UNITED STATES PATENT AND TRADEMARK OFFICE

Office Action Summary

09/437,296

Claim 1 is rejected under 35 U.S.C. 103(a) as being unpatentable over US patent 5967489, Nakazawa et al in view of US patent 5058935, Eidsmore.

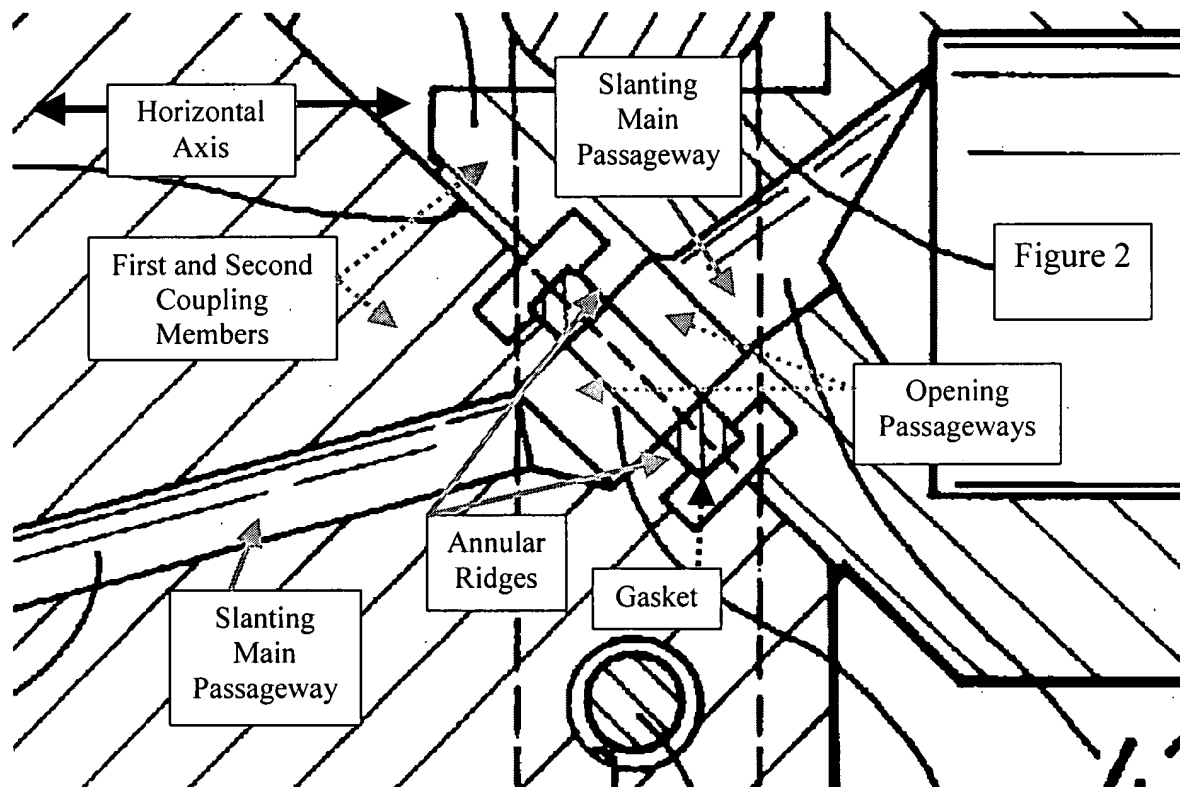
In regards to claim 1, in figure 2 below, Nakazawa et al discloses a fluid coupling comprising first and second coupling members having respective gasket holding annular ridges on butting end faces thereof; and

an annular gasket interposed between the first and second coupling members, wherein each coupling member has a fluid channel comprising an opening passageway orthogonal to the butting end face thereof, and a slanting main passageway

communicating therewith, the opening passageway having a diameter equal to the inside diameter of the gasket holding annular ridge, and

the gasket holding annular ridges are in contact with the gasket at its radial midportion so as (capable) to relieve the inner peripheral portion of the gasket from stress concentration and wrinkles.

Nakazawa et al does not disclose the gasket holding annular ridges being rounded as to be in contact with flat, non-inclined faces of the gasket only at its radial midpoint. In Figure 5, Eidsmore teaches a gasket holding annular ridges (40) being rounded as to be in contact with flat, non-inclined faces of the gasket (42) only at its radial midpoint because this a relatively conventional arrangement well known in the art (col. 4, lines 24-26). As Eidsmore relates to pipe joints employing a metal gasket, it would have been

obvious to one having ordinary skill in the art the time the invention was made to fabricate rounded gasket holding annular ridges as to be in contact with flat, non-inclined faces of the gasket only at its radial midpoint because this a relatively conventional arrangement well known in the art, as taught by Eidsmore.
